Access Compliance Report

Public Rights-of-Way

(Island Curb Cuts)

Intersection ID: 24840	Main Street: REA_RD	Cross Street: MACANDREW_DR	Location: SW
ADA ID: 867B99627F06	Curb Cut Type: MedianRefuge2	Initial Pass/Fail: Fail	Overall Compliance: No
Codes/Mitigation Info/Possible Solution		Field Measurements/Component Compliance	
Severity Score: 0

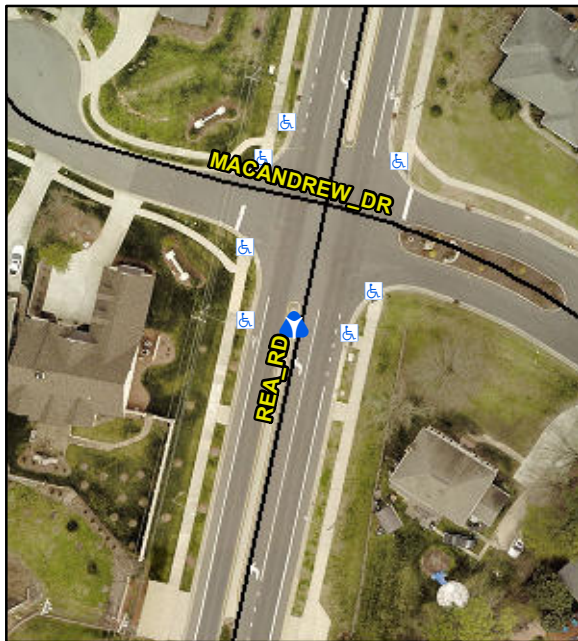
Compliance	Description	Data	Compliance	Description	Data
No	Refuge 1 Length (In)	24.0	N/A	Gutter 1 Ponding?	N/A
Yes	Refuge 1 Width (In)	72.0	N/A	Gutter 1 Lip Ht (In)	N/A
Yes	Refuge 1 Slope (%)	1.8	N/A	Gutter 1 Slope (%)	N/A
Yes	Refuge 1 X Slope (%)	2.3	N/A	Gutter 1 X Slope (%)	N/A
N/A	Painted X Walk1?	No	N/A	DWS 1 Provided?	N/A
N/A	X Walk 1 Direction	To NW	N/A	DWS 1 Contrast?	N/A
N/A	X Walk 1 Width (In)	N/A	N/A	DWS 1 Length (In)	N/A
N/A	Road 1 Slope (%)	0.1	N/A	DWS 1 Full Width?	N/A
N/A	Road 1 X Slope (%)	3.0	N/A	DWS 1 Offset (In)	N/A
No	Refuge 2 Length (In)	24.0	N/A	Gutter 2 Ponding?	N/A
Yes	Refuge 2 Width (In)	72.0	N/A	Gutter 2 Lip Ht (In)	N/A
Yes	Refuge 2 Slope (%)	1.4	N/A	Gutter 2 Slope (%)	N/A
Yes	Refuge 2 X Slope (%)	1.9	N/A	Gutter 2 X Slope (%)	N/A
N/A	Painted X Walk2?	No	N/A	DWS 2 Provided?	N/A
N/A	X Walk 2 Direction	To SE	N/A	DWS 2 Contrast?	N/A
N/A	X Walk 2 Width (In)	N/A	N/A	DWS 2 Length (In)	N/A

Remove & Replace Entire Refuge.
